WHITLEY COUNTY ADVISORY PLAN COMMISSION STAFF REPORT

24-W-SUBD-19 PRIMARY REPLAT APPROVAL

"Rocky Acres", 2795 E. Stalf Rd.

RE: Plat 24-W-SUBD-19 Rocky Acres Engineer Review

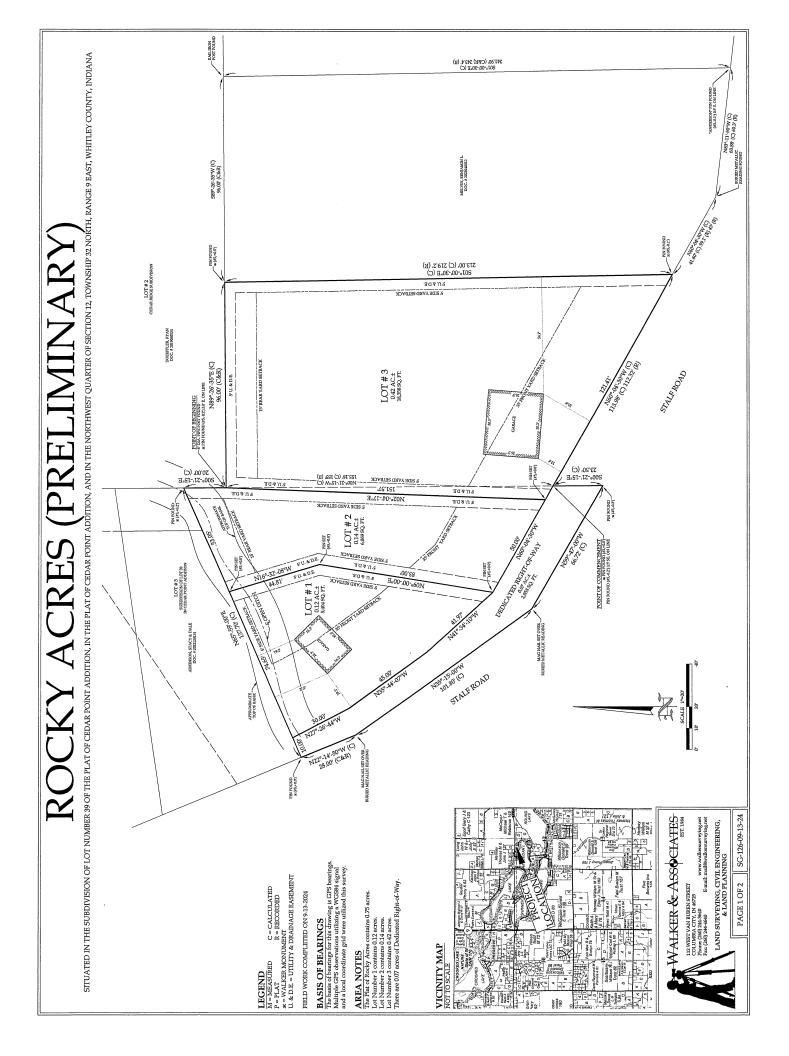
Subdivision primary plats are reviewed for compliance with the standards of Subdivision Control Ordinance and the Zoning Code. Staff finds that the proposed primary plat appears consistent with the standards, with the following condition(s):

- 1. Variances for the lot area and lot width must be obtained.
- 2. Secondary plat approval delegated to the Plan Commission staff.

3. Lots 1 & 2 to have restrictions stating that dwellings may not be placed on them unless code required minimum lot size is met. *This could be better served as a condition of the variance but is listed here for reference or discussion.*
